**Re: Ridgeview Addition– Drainage Study in support of the Preliminary Plat - First Review**

Halff Associates, Inc. was requested by the City of Sanger to provide a review of the drainage study and downstream assessment in support of the preliminary plat for the Ridgeview Addition development. The drainage study prepared Allison Engineering Group was received on November 21, 2022.

**PRELIMINARY PLAT**  
**TOTAL LOTS: 47 RESIDENTIAL**  
**LOTS 1-23, BLOCK A,**  
**LOTS 1-24, BLOCK B**  
**METZ/VIEW ADDITION**

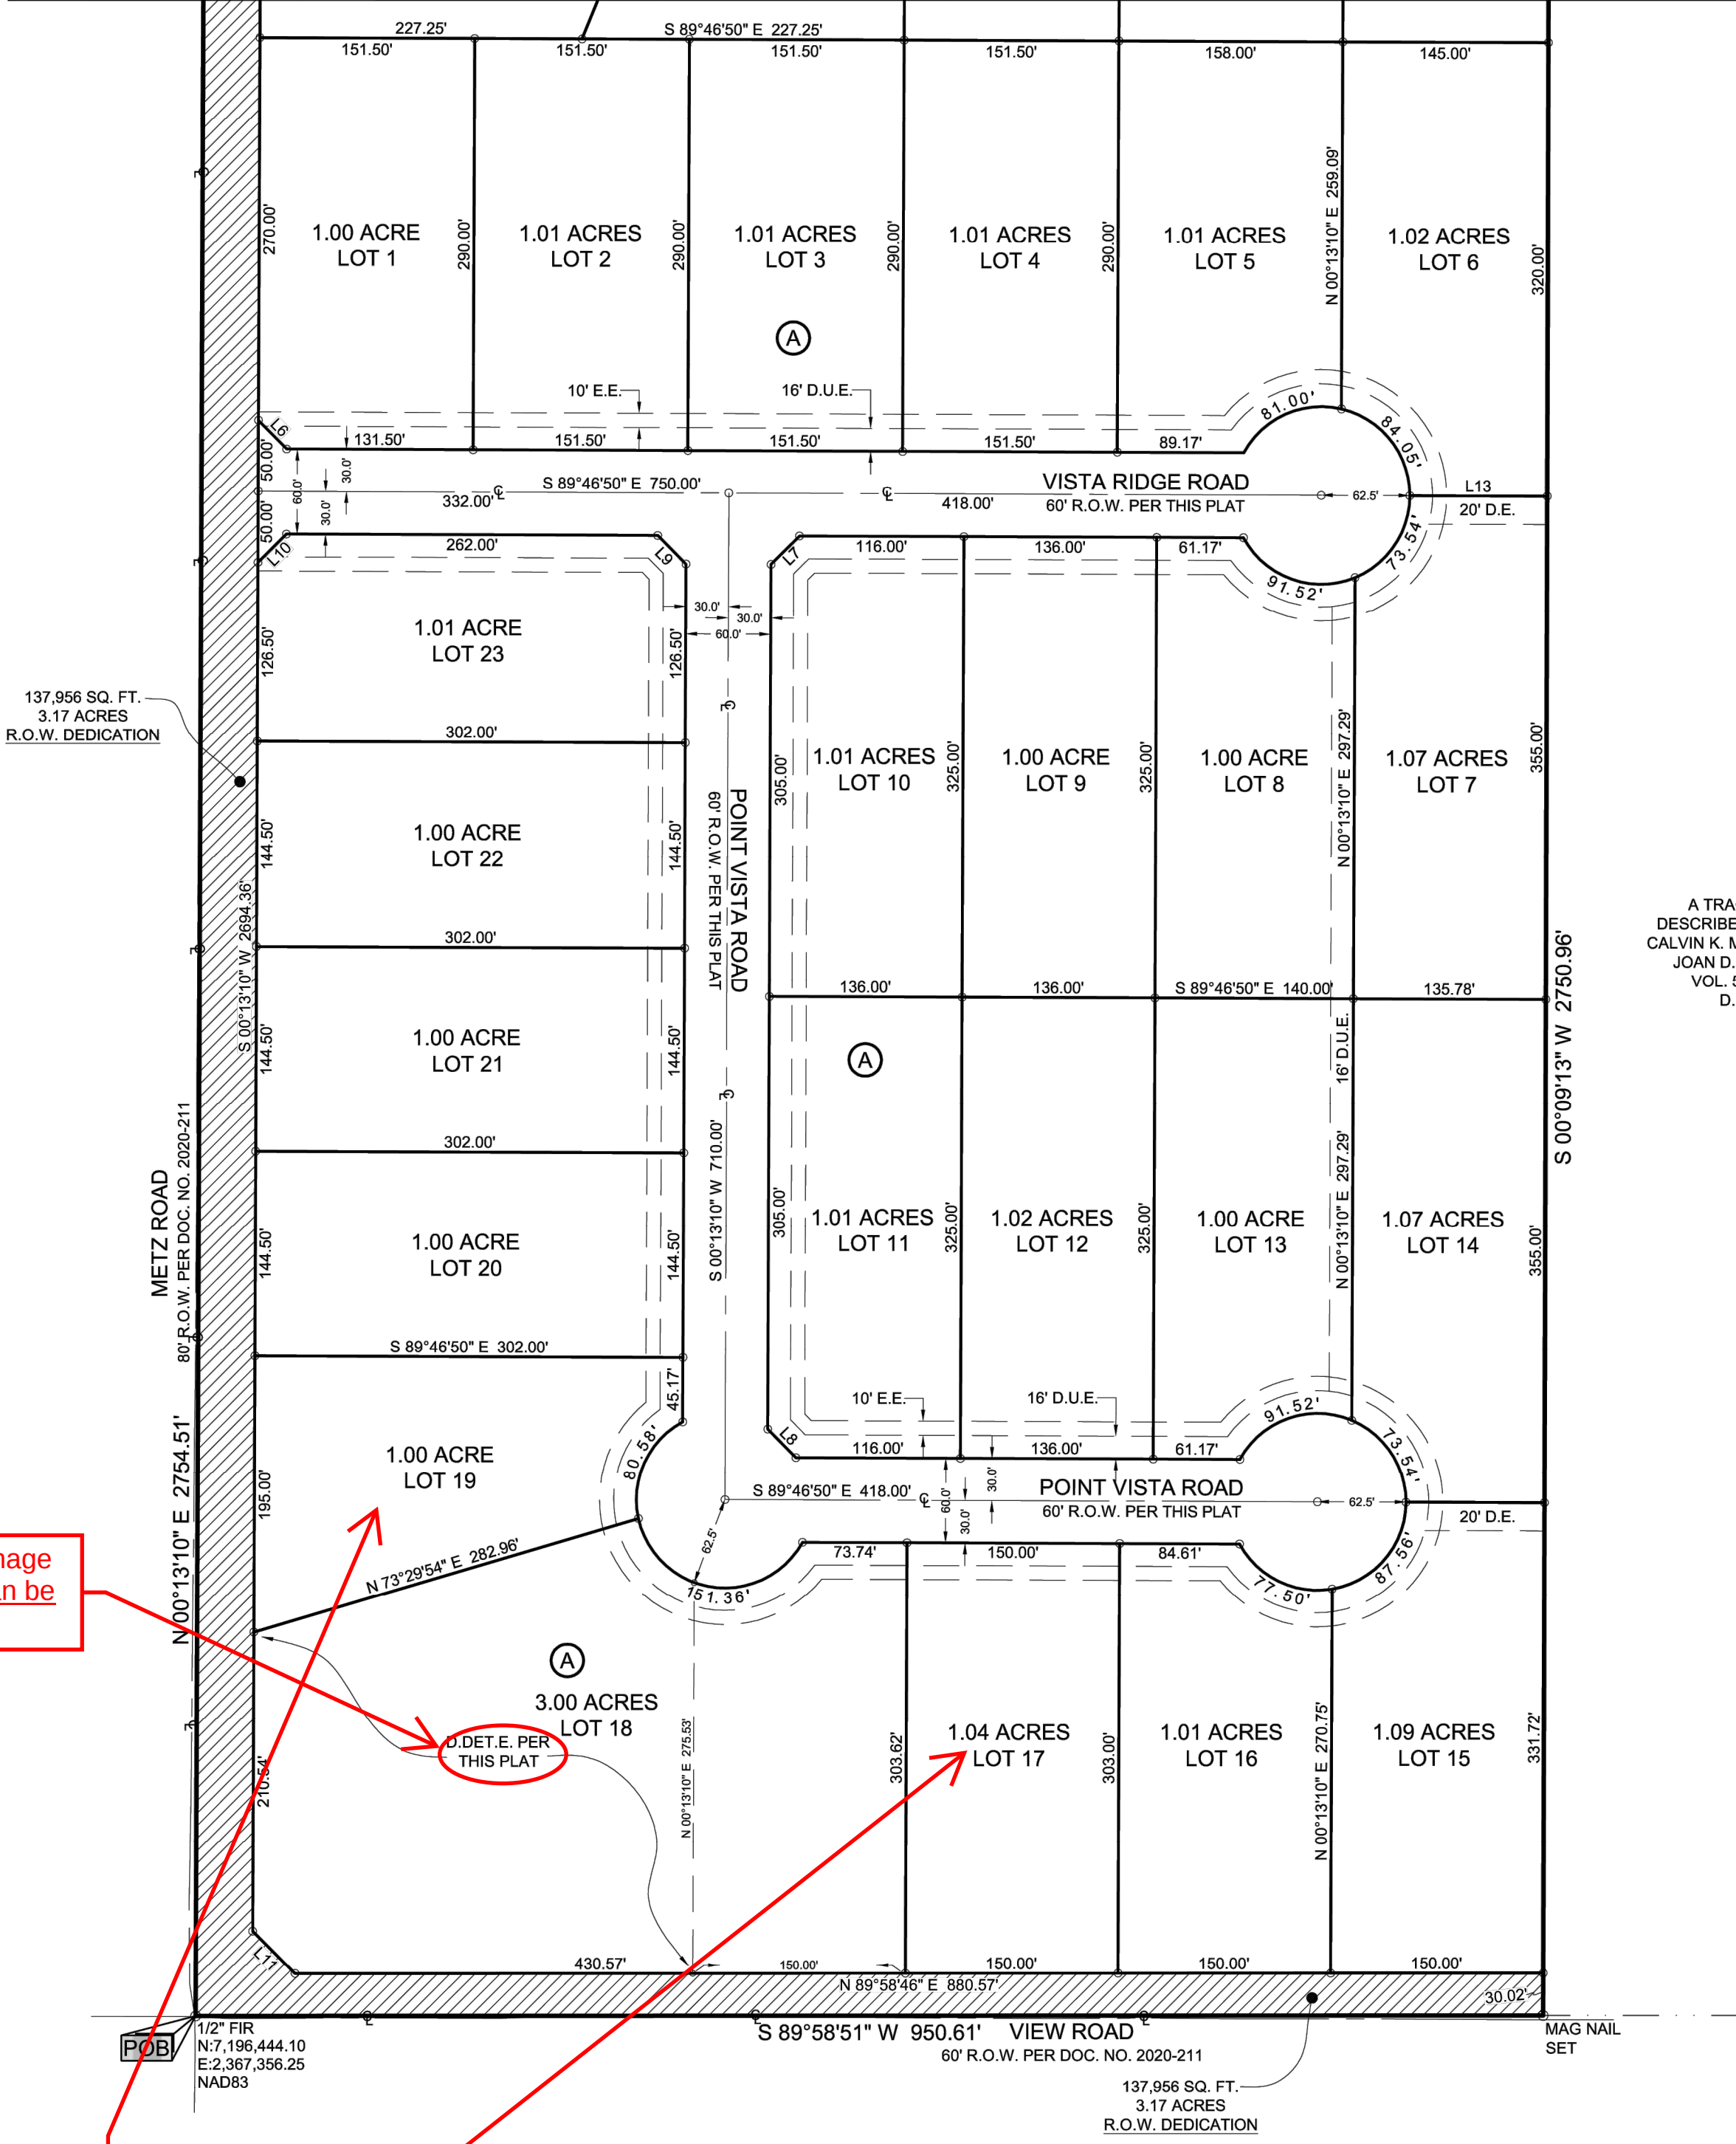
Please label as Private Drainage  
Easement. This comment can be  
addressed with Final Plat.

Provide min FFE for lots around the  
pond. This comment can be addressed  
with Final Plat.

EXISTING DRAINAGE AREA MAP

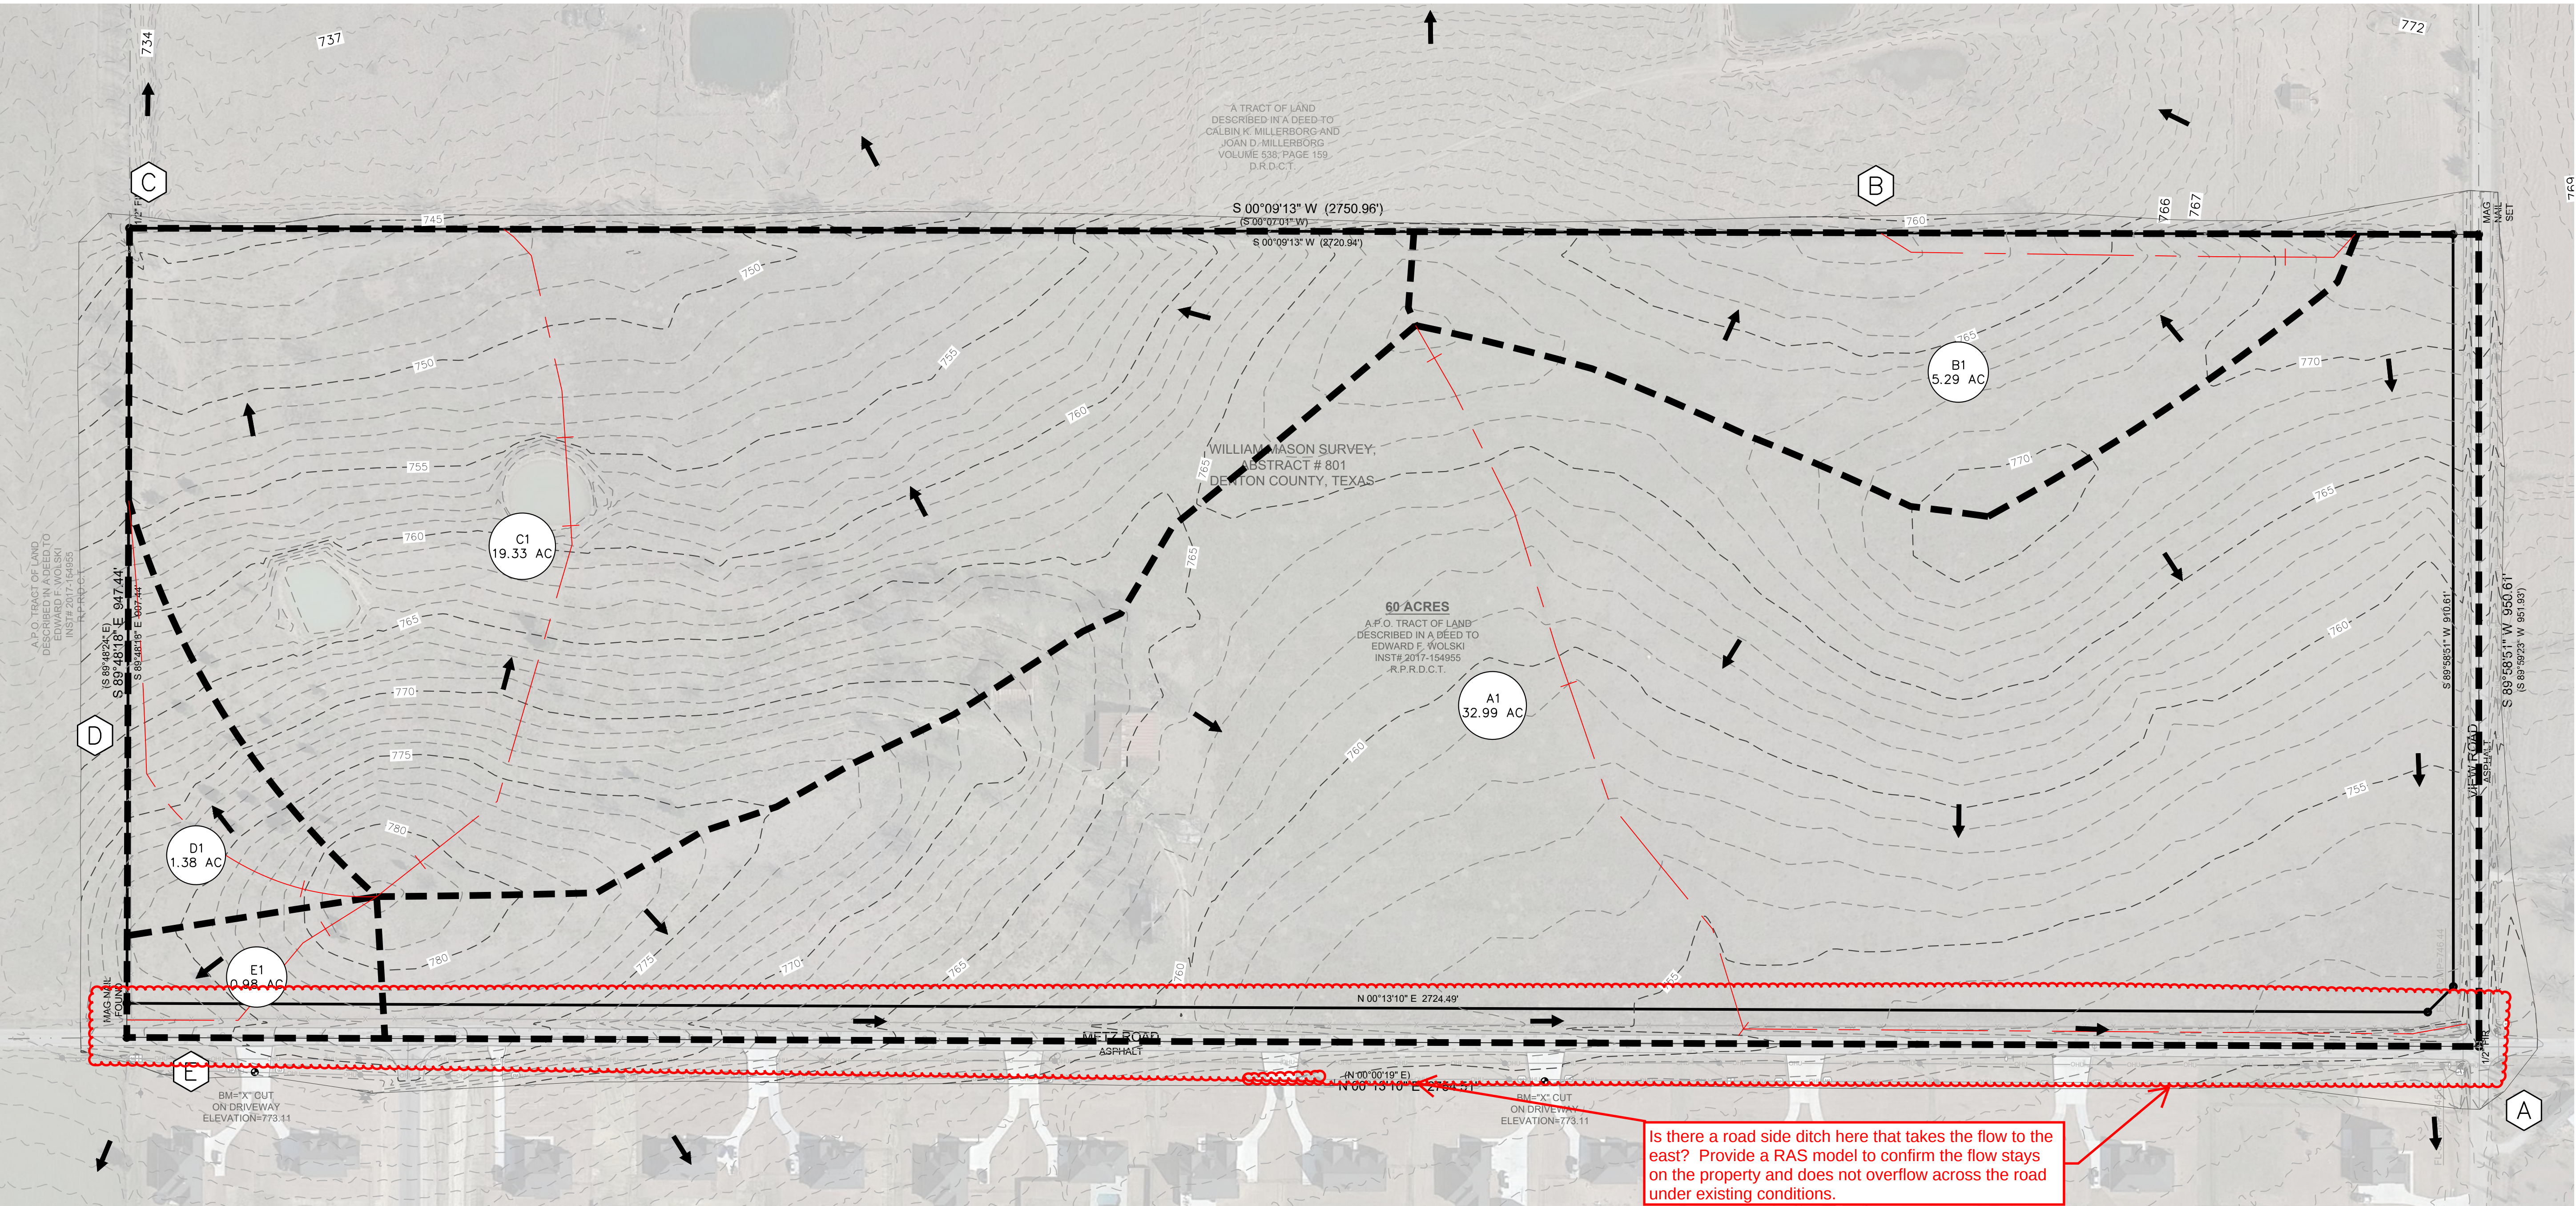
Please verify the calculated Tc.  
Please identify the equation you are using to calculate Tc.

PROPOSED DRAINAGE AREA MAP

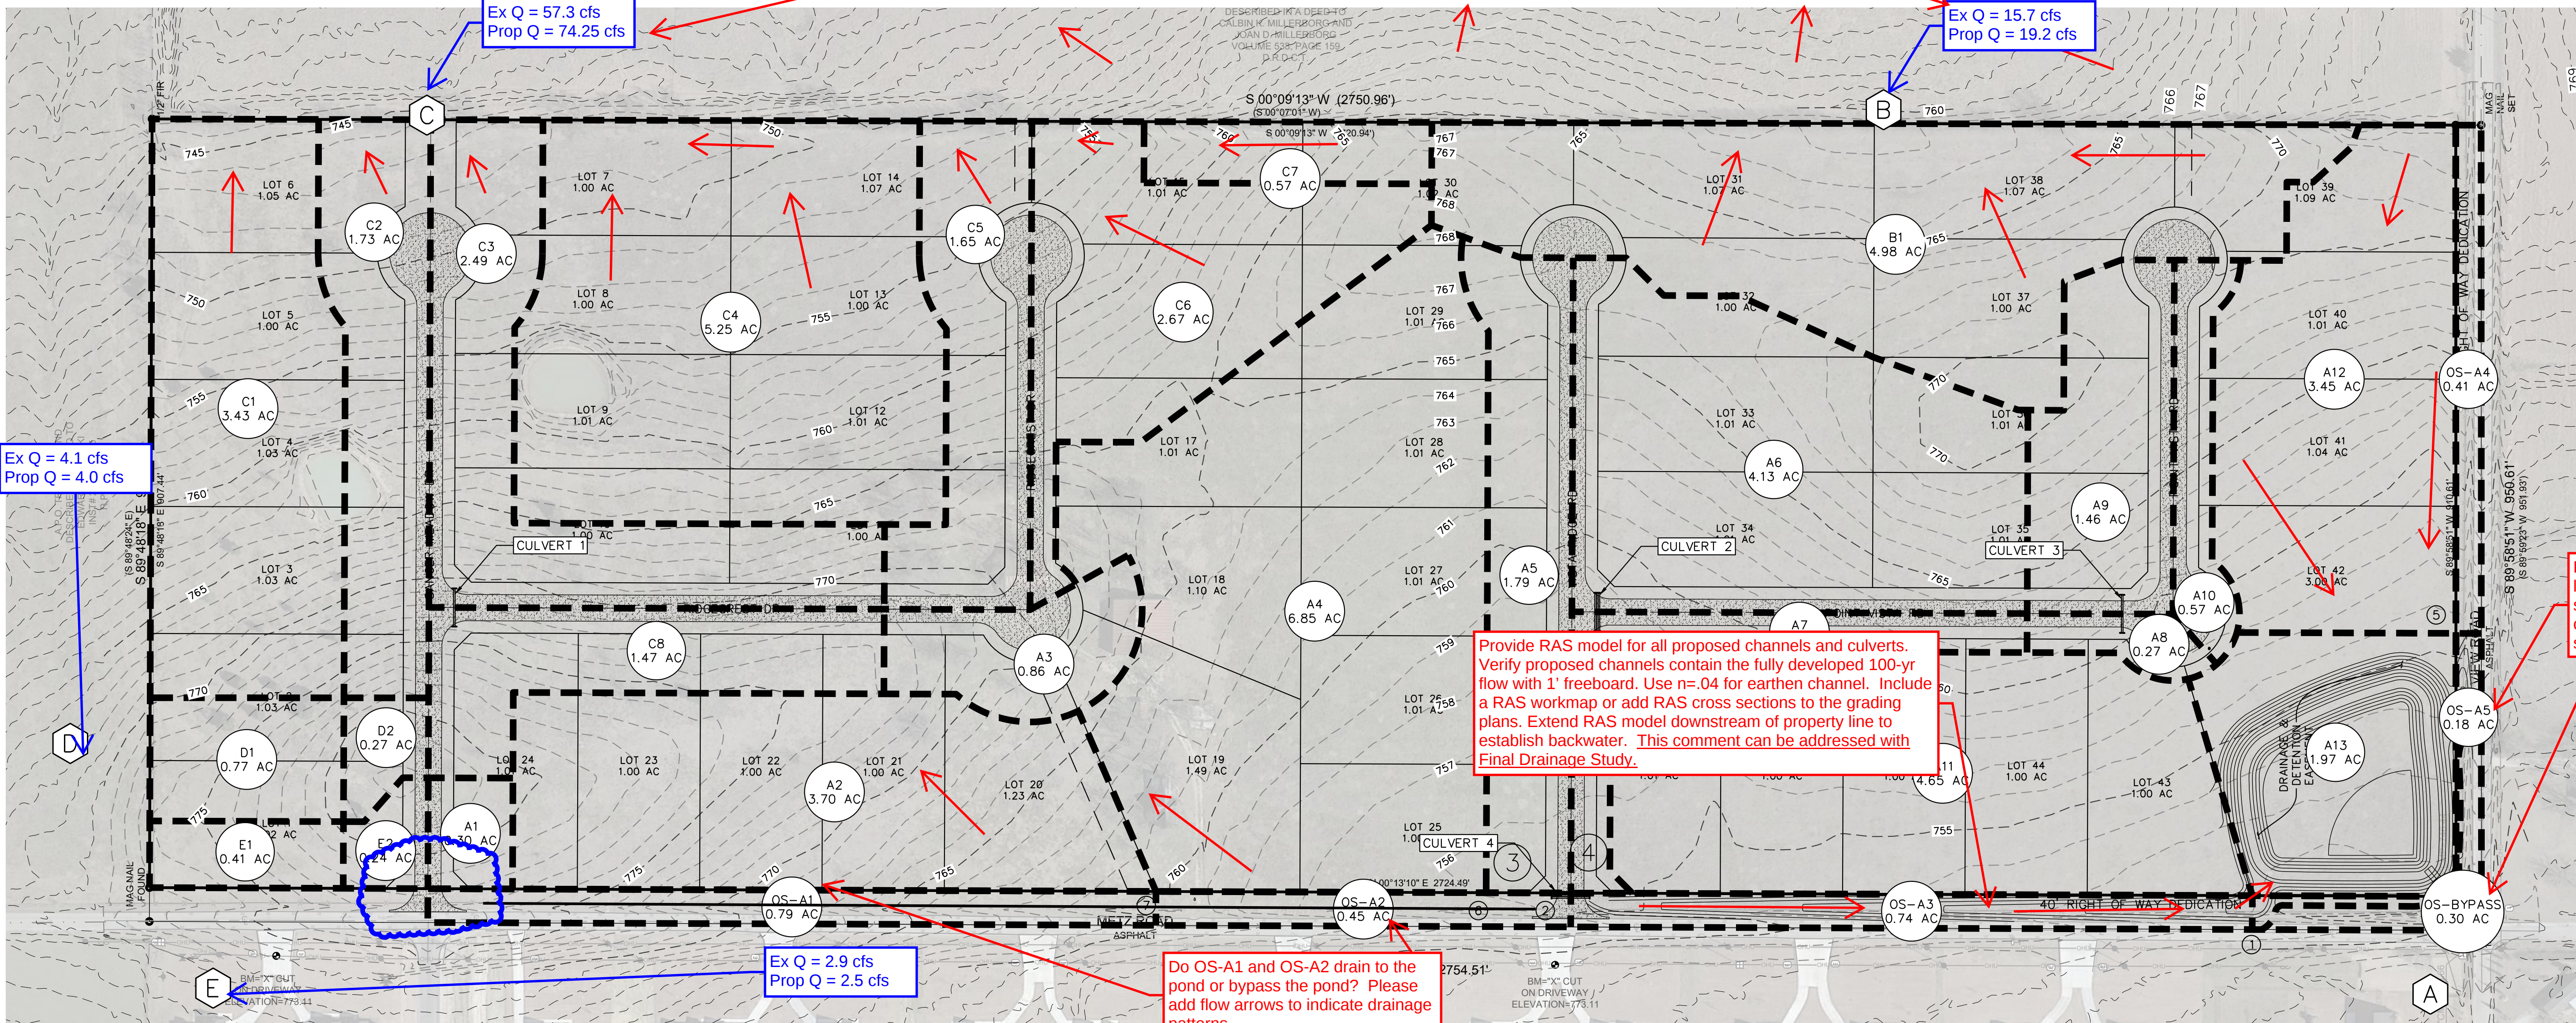
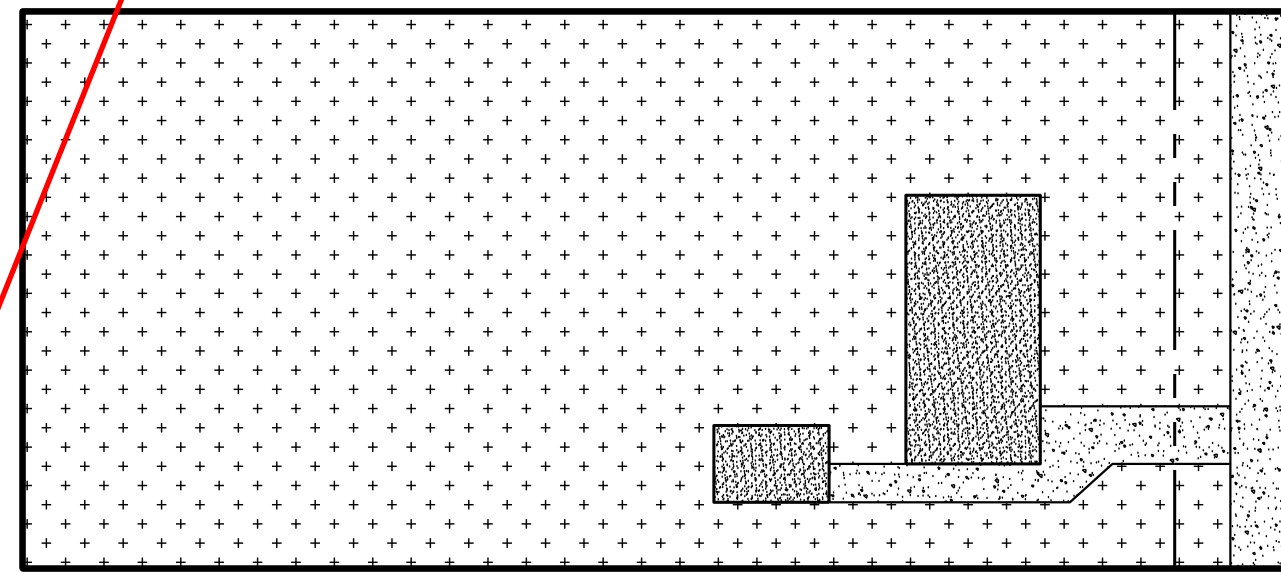
What is the plan to mitigate increases on flow? If obtaining permission for increases from adjacent owner, please provide documentation; include exhibits and calculations.

Please use a C-value of 0.45 per the Denton County standards. See Table IV.1-4.

General Comments:  
1. Please add directional flow arrows onsite and offsite to indicate drainage patterns.  
2. Provide a comparison of existing and proposed flows at each outfall.  
3. Outfalls must be taken to the flow line of the receiving ditch, normal pool of the pond (or) spread back to mimic existing conditions flow spread (or) sheet flow. This comment can be addressed with Final Drainage Study.

Provide RAS model for all proposed channels and culverts. Verify proposed channels contain the fully developed 100-yr flow with 1' freeboard. Use n=.04 for earthen channel. Include a RAS workmap or add RAS cross sections to the grading plans. Extend RAS model downstream of property line to establish backwater. This comment can be addressed with Final Drainage Study.

Please move the labels to clearly show proposed contours and structures.

Do OS-A1 and OS-A2 drain to the pond or bypass the pond? Please add flow arrows to indicate drainage patterns.
